## CONSTRUCTION AND RIGHT-OF-WAY PLANS FOR: BR 1-084 ON N234 TWADDELL MILL ROAD OVER TRIBUTARY TO BRANDYWINE CREEK

CONTRACT NUMBER: T201907103  
FEDERAL AID PROJECT NUMBER: N/A

<b>ADDENDUM PREPARED BY</b> DELDOT - TRANSPORTATION SOLUTIONS BRIDGE DESIGN		
	6/15/26 DATE	
THIS SEAL APPLIES TO THE FOLLOWING SHEETS CHANGED UNDER ADDENDUM #1: 2, 4, 10, 10A		SEAL

APPENDUM 1  
June 22, 2026

SECTION
BR
SHEET NO.
04A

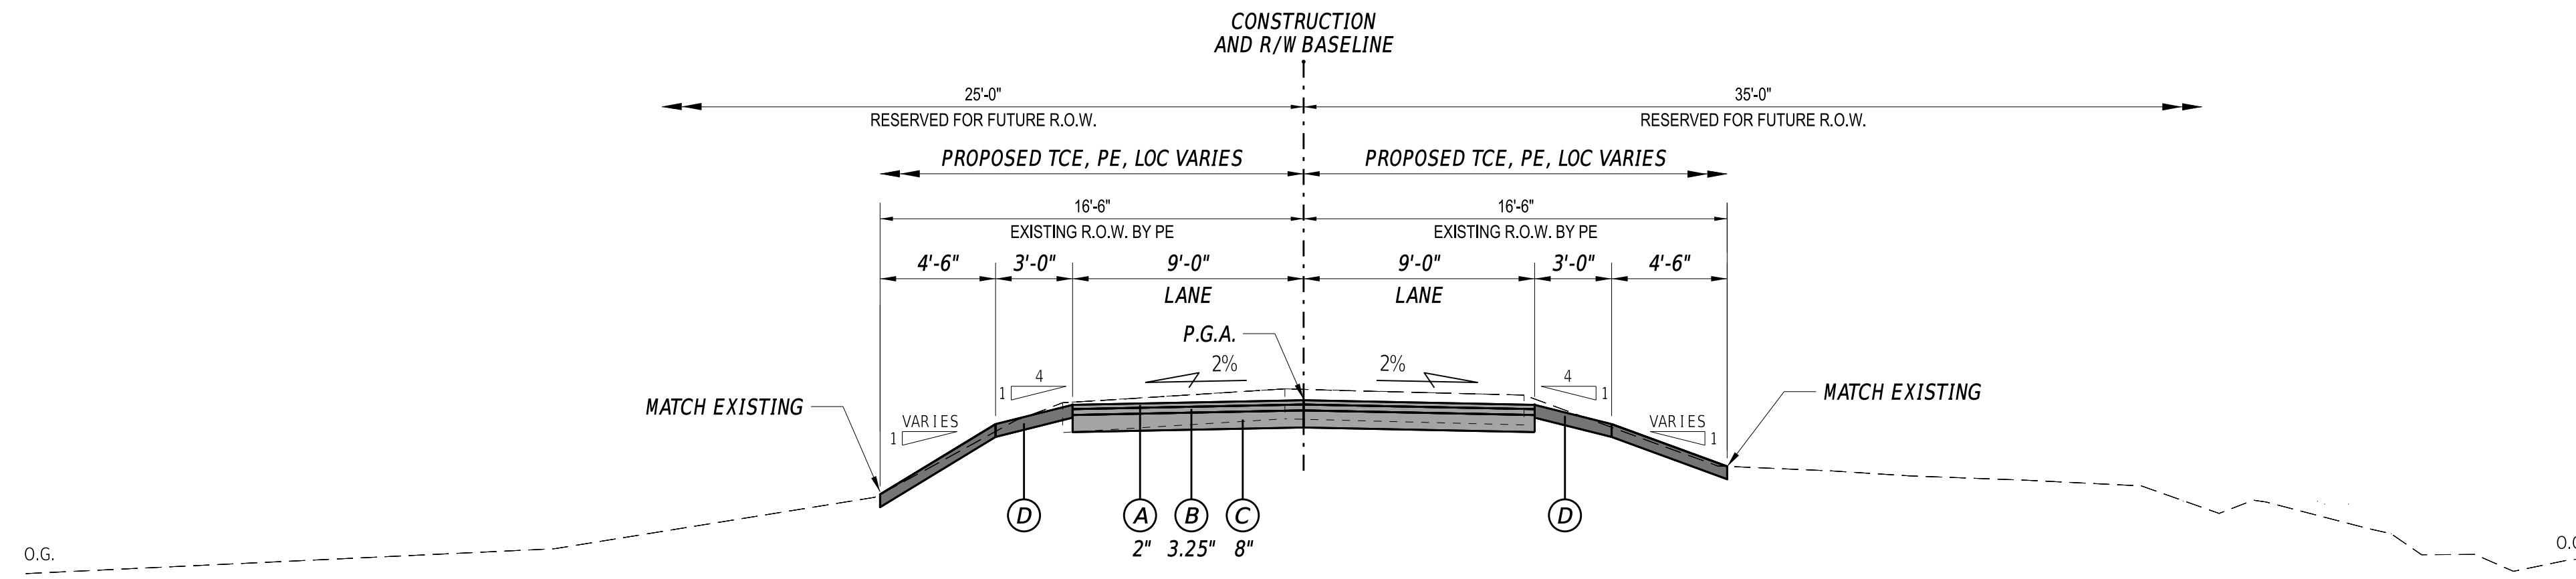
ADDED SECTION 600 NOTES - PCH 6/15/2026

10. PORTLAND CEMENT CONCRETE: USE PORTLAND CEMENT CONCRETE FOR CAST-IN-PLACE ELEMENTS AS FOLLOWS:  
(f'c = 28-DAY COMPRESSIVE STRENGTH)  
CLASS A - HEADERS (ITEM 607012), (f'c = 4.5 ksi)

11. BAR REINFORCEMENT:  
-PROVIDE REINFORCING STEEL CONFORMING TO AASHTO M31 (ASTM A615), GRADE 60.  
-PROVIDE A 3" CLEAR COVER FOR ALL REINFORCING STEEL PLACED IN CONCRETE CAST AGAINST EARTH OR A 2" CLEAR COVER ELSEWHERE, UNLESS OTHERWISE SPECIFIED ON THE PLANS.  
-WHERE A SUFFIX IS INCLUDED IN BAR MARKS, PROTECT ALL REINFORCING STEEL WITH THE MATERIAL DENOTED.  
SUFFIX 'E' DENOTES EPOXY COATED BAR REINFORCEMENT

-WITH APPROVAL OF THE BRIDGE DESIGN ENGINEER, GALVANIZED REINFORCING STEEL MAY BE SUBSTITUTED FOR EPOXY-COATED REINFORCING STEEL AT NO ADDITIONAL COST TO THE DEPARTMENT.

**BRIDGE PLAN, SECTION, AND ELEVATION**

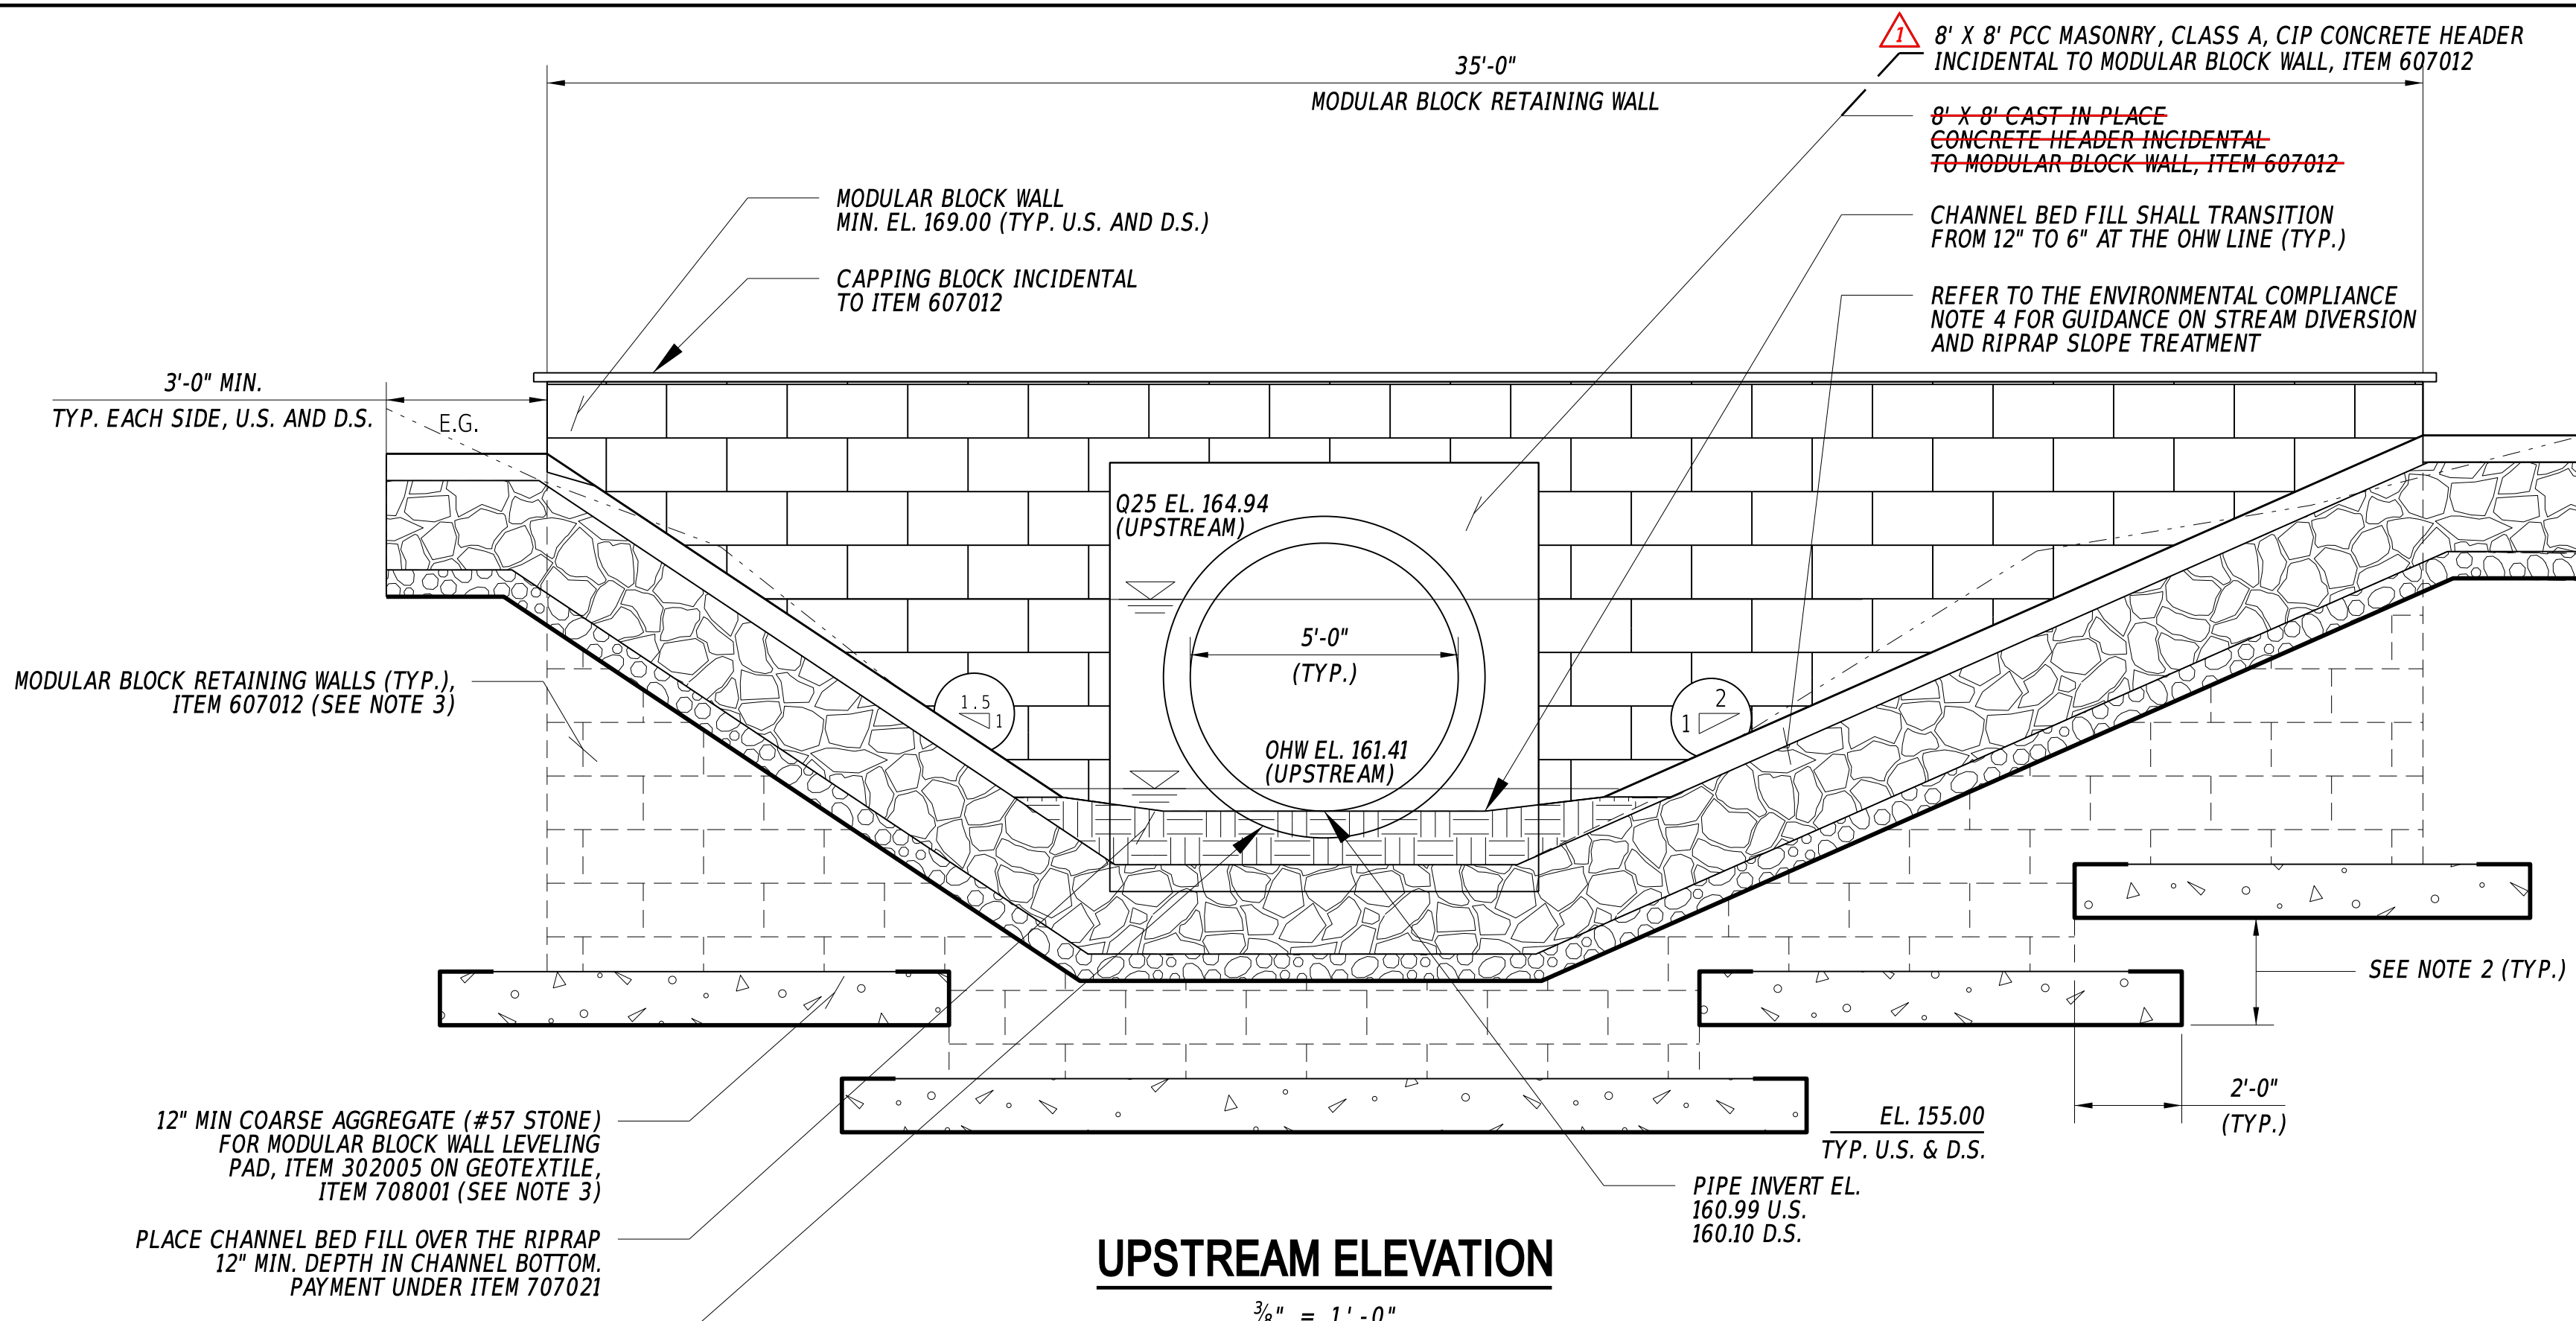
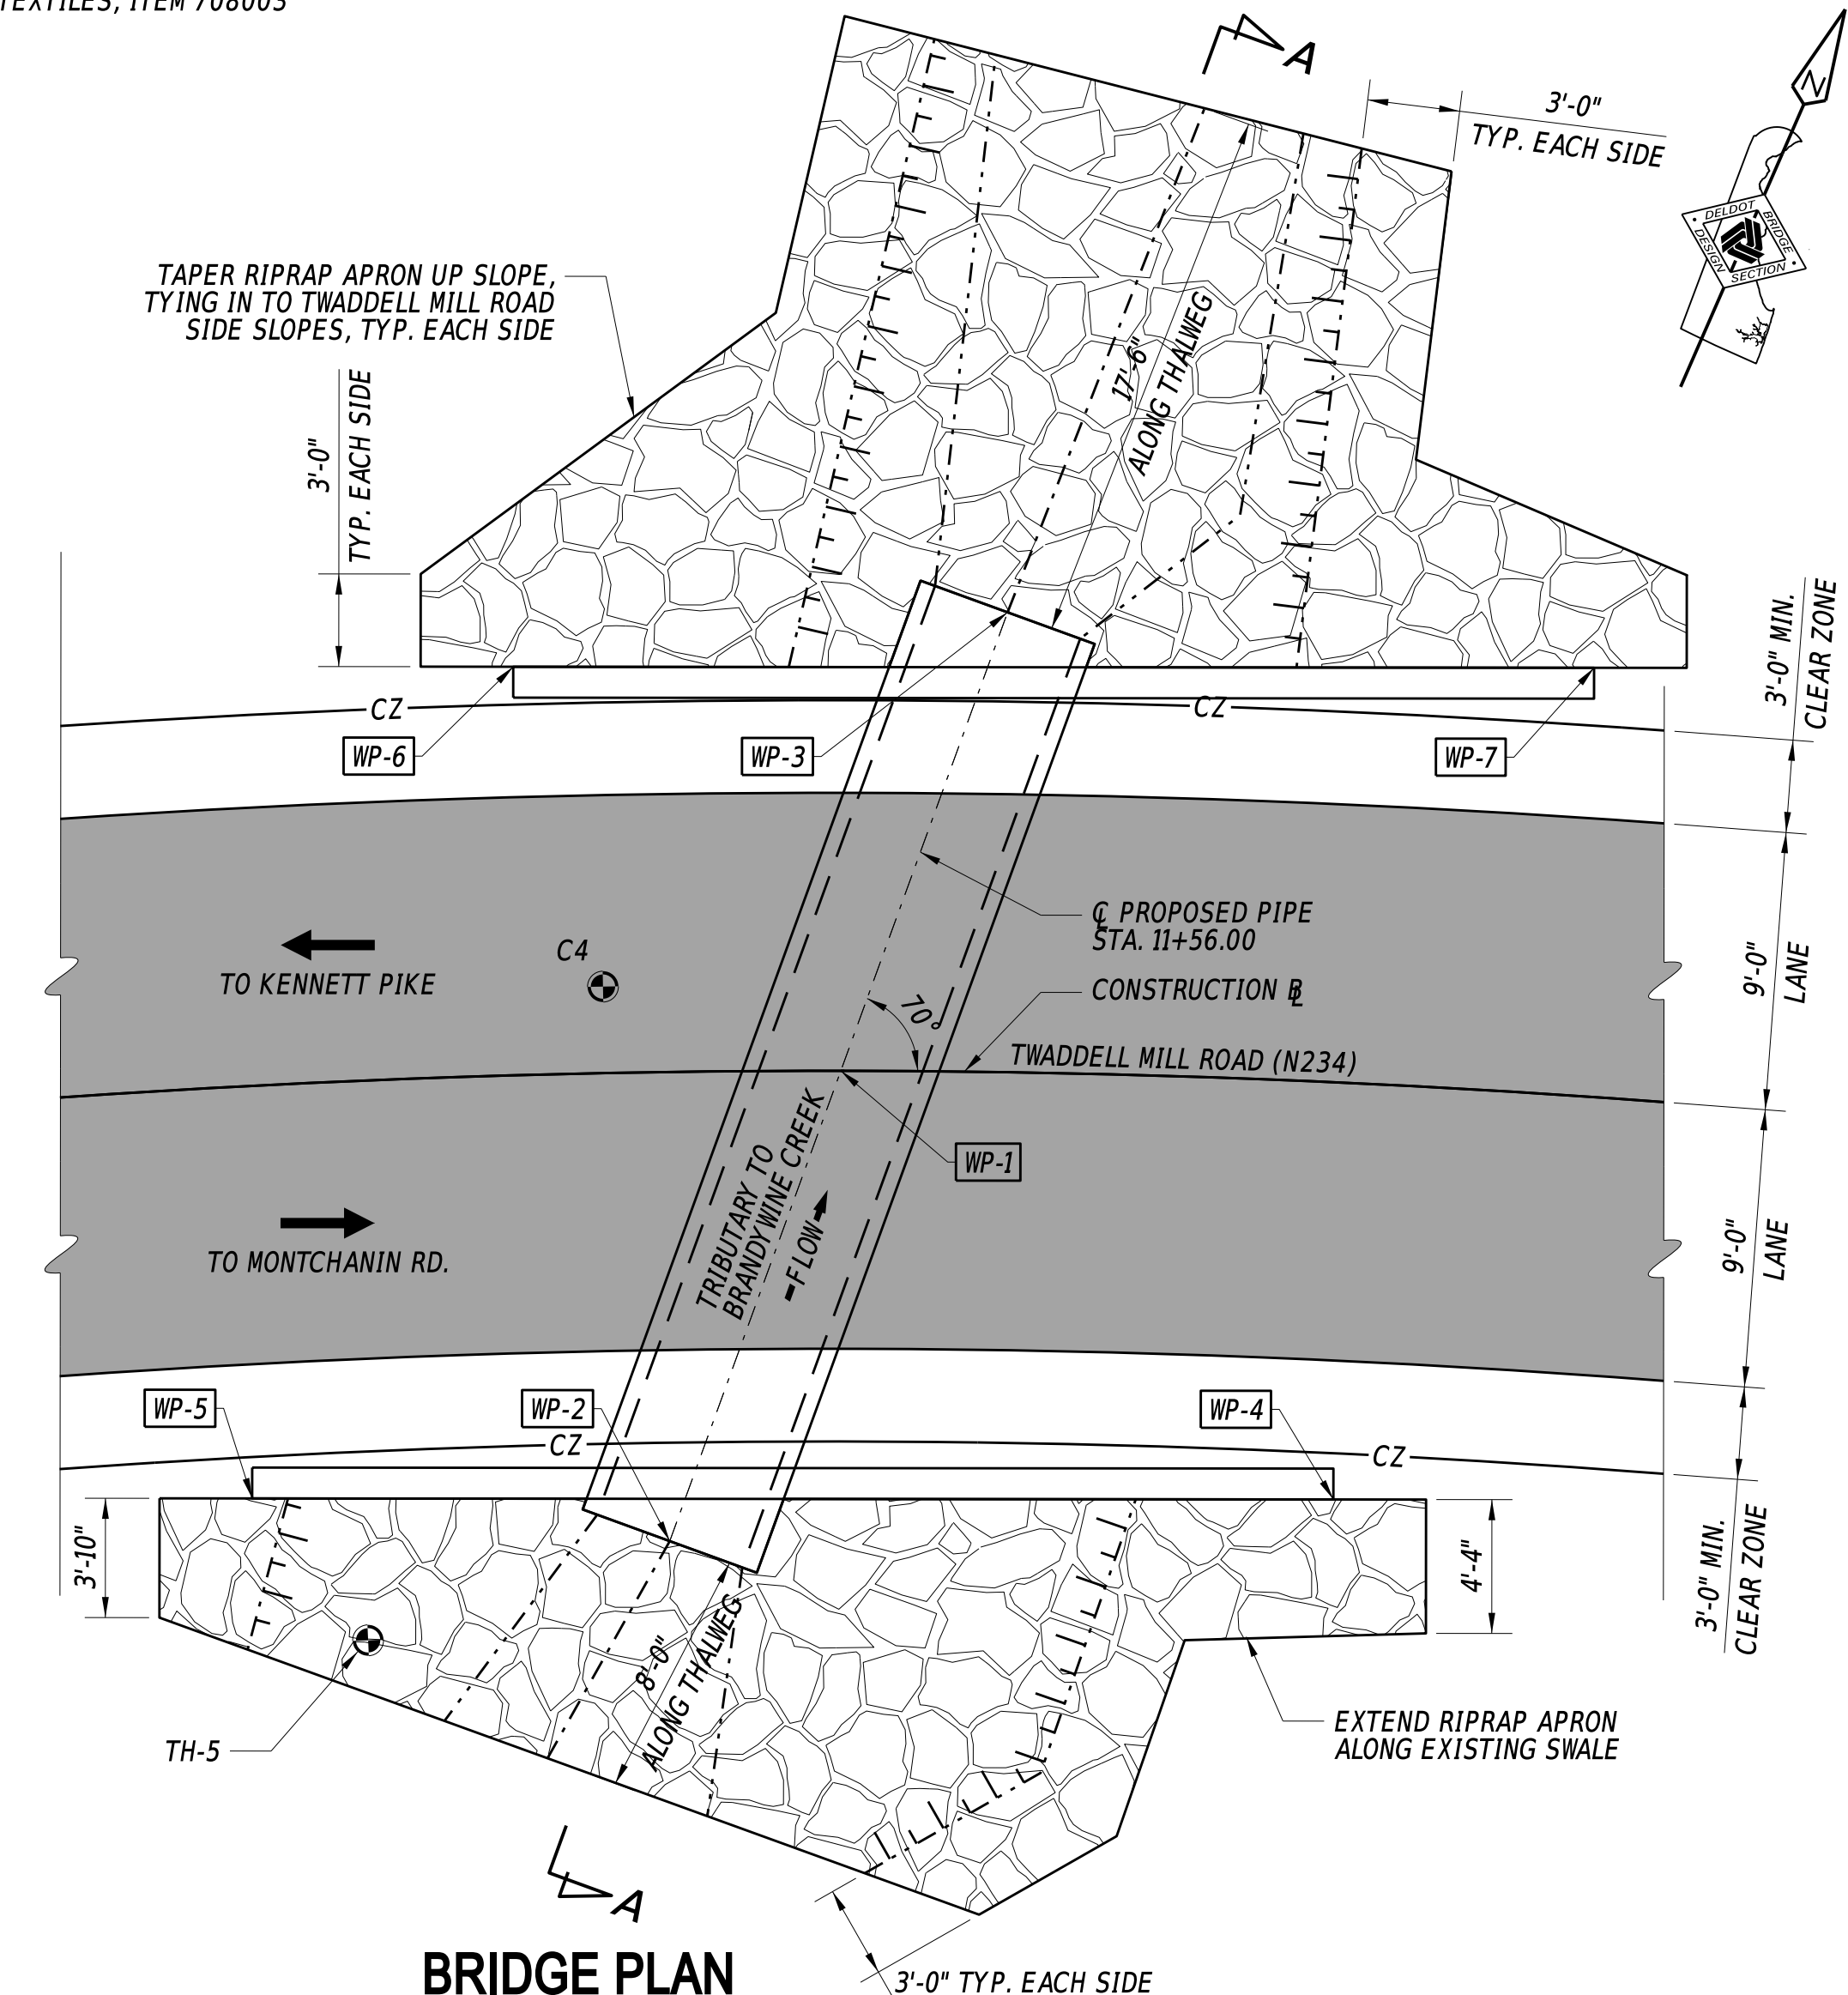
ADDENDA / REVISIONS
REVISOR: REVISED THE NOTES CONCERNING THE CONCRETE HEADER - PCH 6/15/2026

- NOTES:
- IN THE SUBMITTAL (STANDARD SPEC 607.3.1), INCLUDE SHAPE AND SETBACK OF BRICKS WHICH SHALL BE FLAT FACED, AND NEAR VERTICAL. THE COLOR OF THE BRICKS SHALL BE DELAWARE BLUE GRANITE OR SIMILAR, TO BE APPROVED BY ENGINEER.
  - DUE TO MODULAR BLOCK RETAINING WALL BEING DESIGNED BY MANUFACTURER AND VARIATION IN EXISTING CONDITIONS, CONTRACTOR AND ENGINEER WILL DETERMINE WHETHER OR NOT STEPPING OF MODULAR WALL IS NECESSARY. FOR QUANTITY ESTIMATION PURPOSES, IT WAS ASSUMED STEPS OF 2'-0" WERE USED.
  - FOR QUANTITY ESTIMATION OF ITEM 607012, THE DEPTH AND REQUIRED AMOUNT OF MODULAR BLOCK RETAINING WALLS WERE ESTIMATED BASED ON BORING LOGS AND STEPS MENTIONED IN NOTE 2. THE SIZE OF POSSIBLE LEVELING PAD/FOUNDATION FOR MODULAR BLOCK RETAINING WALLS WERE ESTIMATED TO BE 1'-0" DEEP AND 5'-0" WIDE FOR ITEM 708001 - DE #57 STONE.
